Project	IEEE 802.16 Broadband Wireless Access Working Group < http://ieee802.org/16 >	
Title	A Contribution to the TG3/TG4 MAC: MPDU Formats	
Date Submitted	2001-08-10	
Source(s)	Lei Wang Brian Gieschen Wi-LAN Inc. 2891 Sunridge Way, NE Calgary, AB, Canada, T1Y 7K7	Voice: (403)273-9133 Fax: (403)273-5100 Email: LeiW@wi-lan.com ; BrianG@wi-lan.com ;
Re:	This is a follow-up contribution to a tabled motion in Session #13, regarding the contribution 802.16.3c-01/62.	
Abstract	This document refines two proposed enhancements to the MPDU formats in the previous contribution, 802.16.3c-01/62. First, A new payload type is introduced, called a super MPDU, to directly and efficiently support the concatenation of MPDUs with different CIDs. Second, we propose a new arrangement of the header/payload locations in order for the receiver to process the incoming MPDUs more efficiently.	
Purpose	Enhance the MPDU formats for the TG3 and TG4.

This document refines two proposed enhancements to the MPDU formats in the previous contribution, 802.16.3c-01/62. First, A new payload type is introduced, called a super MPDU, to directly and efficiently support the concatenation of MPDUs with different CIDs. Se

FIGURE 1. MPDU Concatenation Using Super MPDU

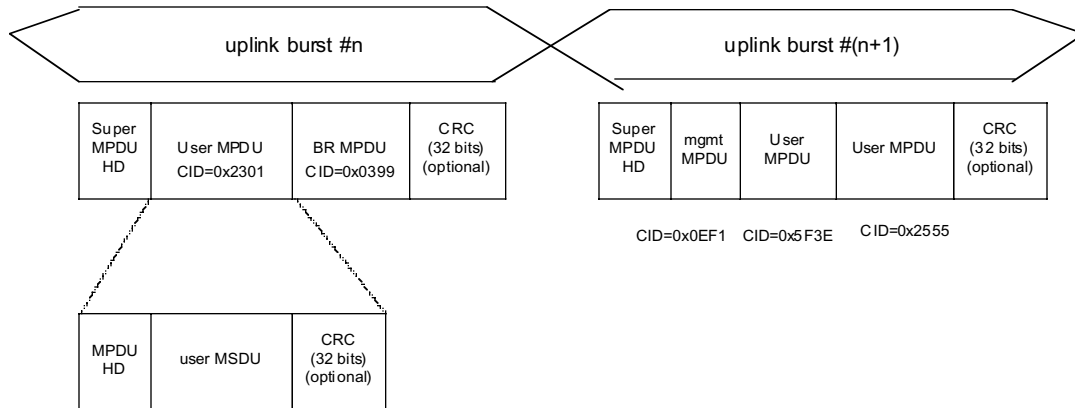
Multiple MPDUs may also be concatenated into a single super MPDU of a single transmission in either the uplink or downlink directions. FIGURE 1 illustrates MPDU concatenation using the super MPDU concept for an uplink burst transmission.

FIGURE 3. Proposed Locations of the Packing Sub-Headers and Payloads

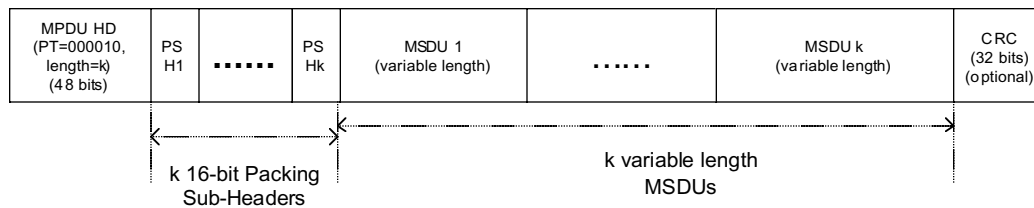
Packing is the mechanism described in TG1 document, section 6.2.3.4, to have multiple MSDUs packed into a single MPDU. In order to improve the efficiency of processing packing MPDUs with variable-length MSDUs at the receiver side, we propose an enhancement to the locations of the packing sub-headers and their payloads, as shown in FIGURE 3.

- add the subclause: 6.2.3.4.2 Packing Variable-Length Packets; with the TG1 context;
- replace Figure 30 in the original context with Figure 3 given in this document;
- add the following paragraph right after the new Figure 30:

The multiple packing sub-headers are gathered together and located before their payloads. At the receiving side, the headers become available to be processed before their payloads arrive, so that such a packing sub-header/payload location arrangement allows more prompt and efficient header processing for the packing MPDUs.
